Re: BusConnects Bray to City Centre Core Bus Corridor Scheme

BusConnects Bray to City Centre Core Bus Corridor Scheme An Bord Pleanála Case Reference: HA27,317742

Bray to City Centre Core Bus Corridor Scheme Compulsory Purchase Order 2023 An Bord Pleanála Case reference: KA27.317780

Figure 2: Location of approved outdoor classroom

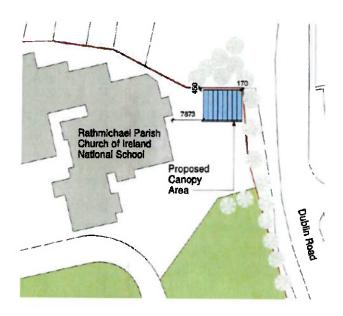
It should also be noted that planning permission was granted in May 2023 for the construction of an outdoor canopy for an outdoor classroom the north eastern corner of site immediately adjacent to the construction area (in location 6 in Figure 1 above). The existence of this proposal has not been factored into the Scheme design and the Board would require that its construction is not impacted by the Scheme.

Figure 3: Extract of Map 44: Emerging Preferred Route February 2019 (NTA)

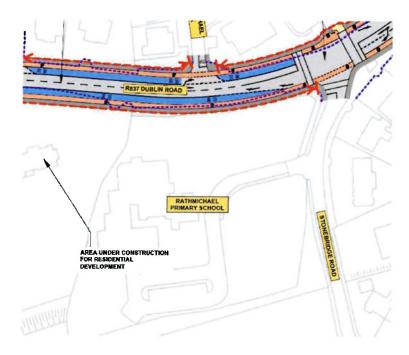
The Emerging Preferred Route that was the subject of public consultation in February 2019 indicated that one bus lane, one general traffic lane and a single segregated cycle track was to be provided in each direction on Dublin Road to St Anne's Church to the south. It was further indicated that the existing Dublin Road/Stonebridge Road junction was intended to be upgraded to facilitate bus priority. (See Figure 3 overleaf.)

Figure 4: Extract of Map 44: Preferred Route March 2020 (NTA)

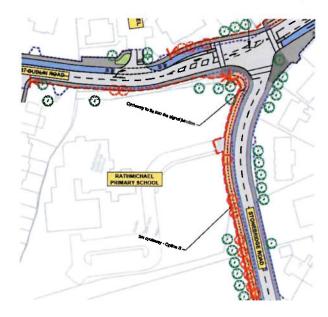
As a consequence of the consultation process, the Emerging Preferred Route was changed – the segregated cycle tracks on Dublin Road between Loughlinstown Roundabout and Stonebridge Road were omitted and a two-way cycle track from the Shanganagh Road/Dublin Road Junction along the Dublin Road and along Stonebridge Road as far as St Anne's National School was included to provide a local cycle link to the two schools. The NTA stated that "these proposals have been introduced following local community engagement and consideration of submissions from the public." (See Figure 4 below).

Figure 5: Proposed cycle tracks (highlighted in blue)

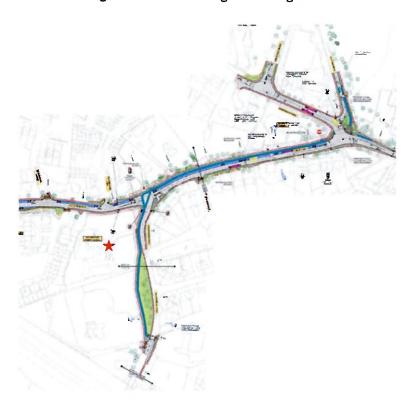
The utility of the proposed cycle tracks and the achievement of their stated purpose are questioned. As shown in Figure 5 below the cycle tracks do not link the two schools to the wider area. There are no segregated tracks on Dublin Road – these were omitted from the Emerging Preferred Route; at the proposed reconfigured Corbawn Lane/Dublin Road junction the very short section of cycle track on Corbawn Lane is separated from the track on the eastern side of Dublin Road by a pedestrian priority zone; and there are no segregated tracks along Corbawn Lane or along Dublin Road through the village centre.

The proposed cycle tracks do not form part of a larger network and whose benefit to connectivity in the wider area has not been assessed or justified in the Scheme.

The fact that the tracks are proposed as a consequence for local consultation and did not form part of the published Emerging Preferred Route, they are clearly not integral to the achievement of the overall Scheme objectives.

The impact of the land take to provide the tracks, which falls exclusively and disproportionately on the school, will be substantial and having regard to the above is not required and therefore unjustified.

The Board considers that the proposal in the Scheme to provide cycle tracks along the northern side of Stonebridge Road must be reconsidered and should be reviewed with a view to omitting them from the overall Scheme as their benefit to connectivity in the wider area has not been assessed or justified in the Scheme.
